REGULATION No. 48

(Installation of lighting and light-signalling devices)

Draft proposal for amendments to regulation No. 48

Figure 2 Illumination vs swivel angle

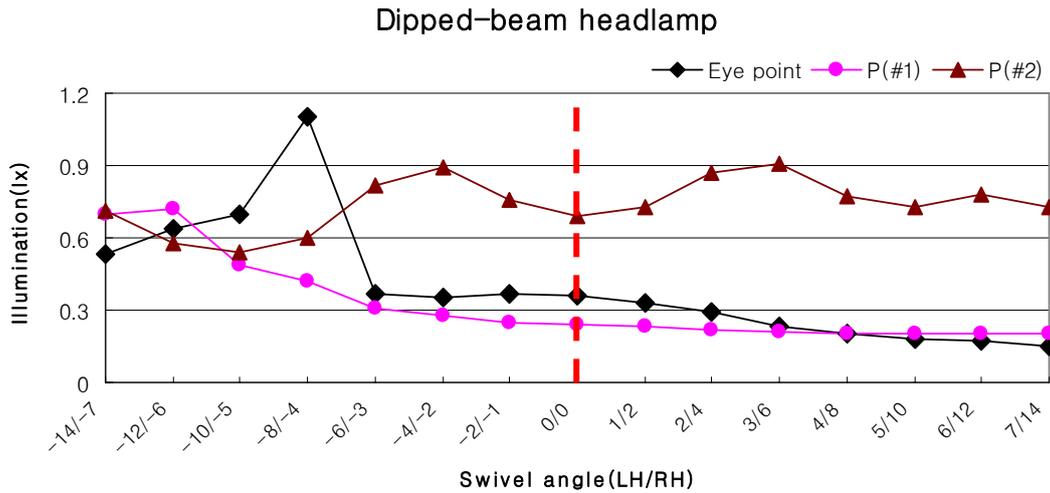
In case of dipped-beam headlamp while a vehicle was at rest in right hand traffic, the measured value was 0.36 lx at the LH(0°), RH(0°) of swivel angle. The measured values at the eye points of an oncoming driver were tended to decrease as the headlamp turned to the right. However, the measured values at the eye points of oncoming driver were tended to increase as the headlamp turned to the left. The fig. 2 showed the illumination vs swivel angle.

Paragraph 6.2.9. of Reg. 48 forbids dipped-beam headlamp from turning to the left in right hand traffic because bend lighting produced by dipped-beam headlamp caused glare to the oncoming driver in Figure 2. For the same reason, a similar requirement is proposed to be inserted for the main-beam headlamp.

Figure 3 Illumination vs swivel angle

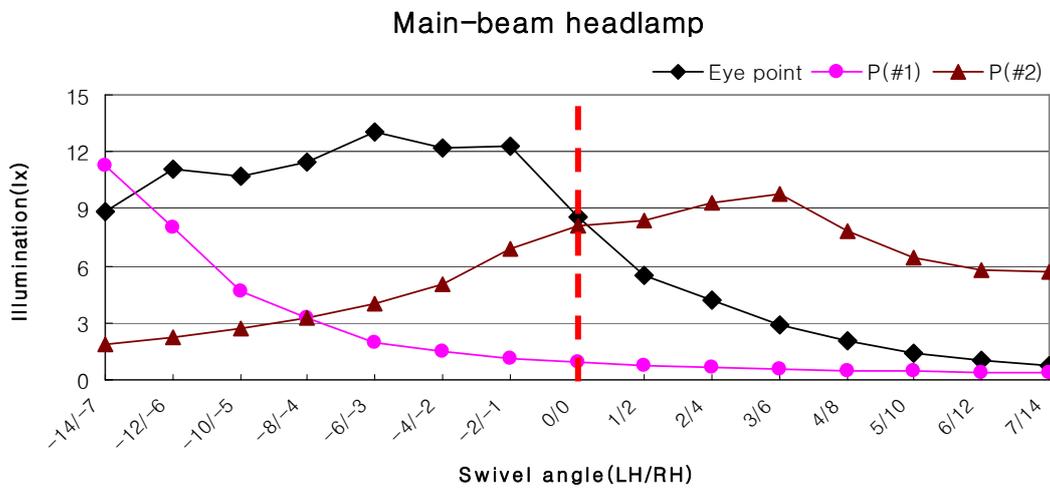
In case of main-beam headlamp while a vehicle was at rest in right hand traffic, the measured value was 8.6 lx at the LH(0°), RH(0°) of swivel angle. The measured values at the eye points of an oncoming driver were tended to decrease as the headlamp turned to the right. However, the measured values at the eye points of oncoming driver were tended to increase as the headlamp turned to the left. The fig. 3 showed the illumination vs swivel angle.
